From: GCC Corporate Mail <gccmail@gcc.tas.gov.au>
Sent: Friday, 24 November 2023 4:37 PM
To: TPC Enquirv
Cc:
Subject: PLAM-22/04 - Response to directions dated 17 October 2023 - GLE-S8.0 Principal Activity Centre Urban Design SAP
Attachments: ECM_3319540_v4_PLAM-22-04 - Response to TPC directions dated 17 October 2023 - Cover letter.pdf; ECM_3298732_v19_PLAM-22_04 - Response to TPC directions dated 17 Oct 2023 - Attachment 1 - MODIFIED DRAFT Amendment.docx; ECM_3319546_v1_PLAM-22_04 - Response to TPC directions dated 17 October 2023 - Attachment 2 - MODIFIED Instrument o.docx

**RESPONSE TO POST-HEARING DIRECTIONS
TASMANIAN PLANNING SCHEME – GLENORCHY - DRAFT AMENDMENT PLAM-22/04
PROPOSED SPECIFIC AREA PLAN – PRINCIPAL ACTIVITY CENTRE**

GLE-S8.0 Principal Activity Centre Specific Area Plan

Image 3 – Glenorchy Activity Centre Urban Design Specific Area Plan to be deleted from the General Overlay maps.

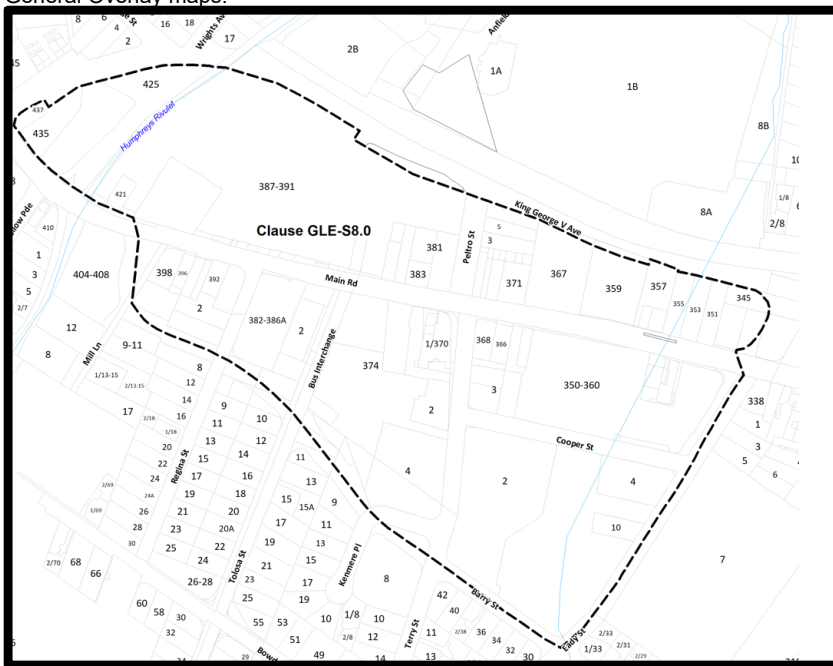
3. Modifying the General Overlay to delete the spatial application of GLE-S8.0 Glenorchy Activity Centre Urban Design Specific Area Plan shown in Image 3 of Annexure 2

Image 4 – Area of GLE-S8.0 Principal Activity Centre Specific Area Plan to be inserted into the General Overlay Maps

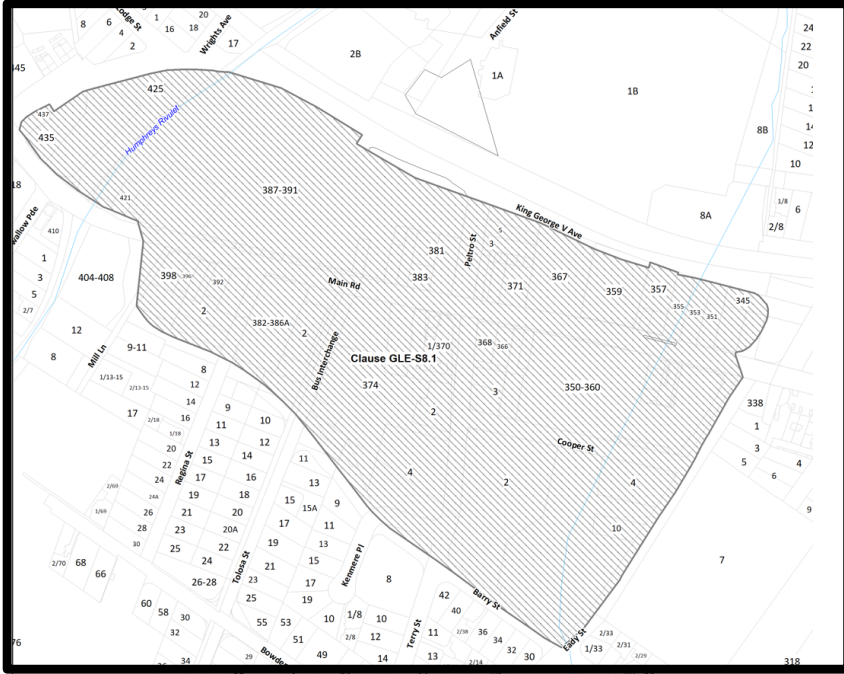
4. Modifying the General Overlay to insert the spatial application of GLE-S8.0 Principal Activity Centre Specific Area Plan as shown in Image 4 of Annexure 2
